Re: **Montgomery Place, LLC**
Amended Preliminary/Final Major Site Plan – Building #2
County Club Meadows, LLC
Block 5023, Lots 2 and 3
BMPUD Belle Mead Planned Unit Development

Date: December 2, 2021

RE: Montgomery Place, LLC
Pike Run Plaza, Retail Building #2
**Amended Preliminary and Final Site Plan
Variance Plan
Application #PB-04-21**
2311 US Highway 206
Block 5023, Lot 2 and 3
Township of Montgomery
Somerset County, New Jersey

To: Montgomery Township Site Plan/Subdivision Committee
From: Lauren A. Wasilauski, Open Space Coordinator
Date: December 2, 2021
Re: PB-04-21: Montgomery Place, LLC
Block 5023 Lot 2.01; ("Montgomery Place", formerly "Pike Run Plaza" / Area #2)
Amended Preliminary and Final Site Plan

Figure 1 - Building Identification Plan

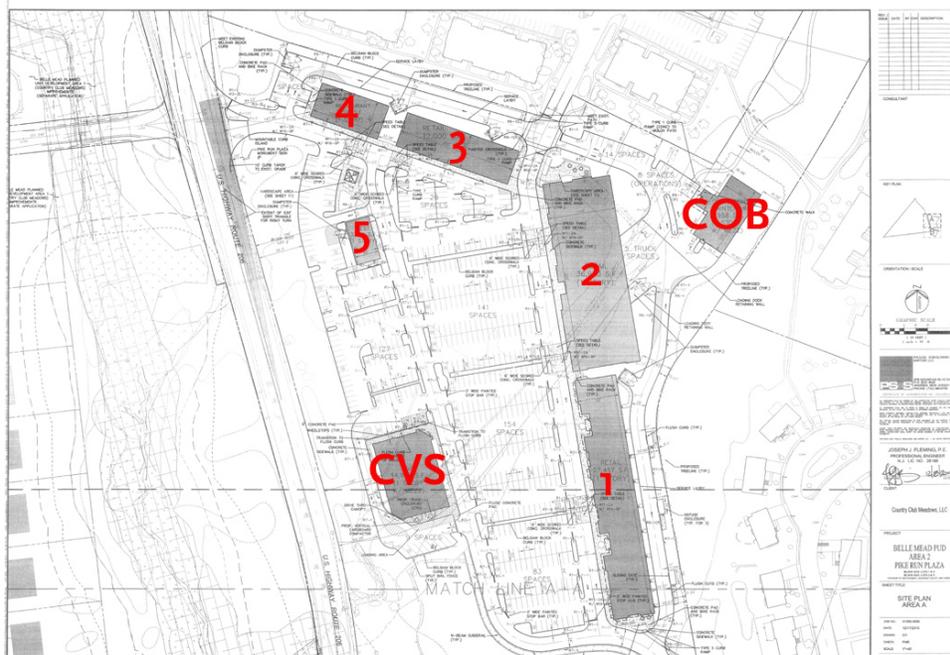
- 1.4 In order to easily discuss compliance of the various buildings, this office has identified the buildings as follows and shown on Figure 1 below. Building 2 is the subject of this review memorandum only. Information pertaining to Buildings 4 and 5 has not been submitted at this time. Prior to the issuance of building permits, the applicant must obtain final site plan approval for Buildings 4 and 5.
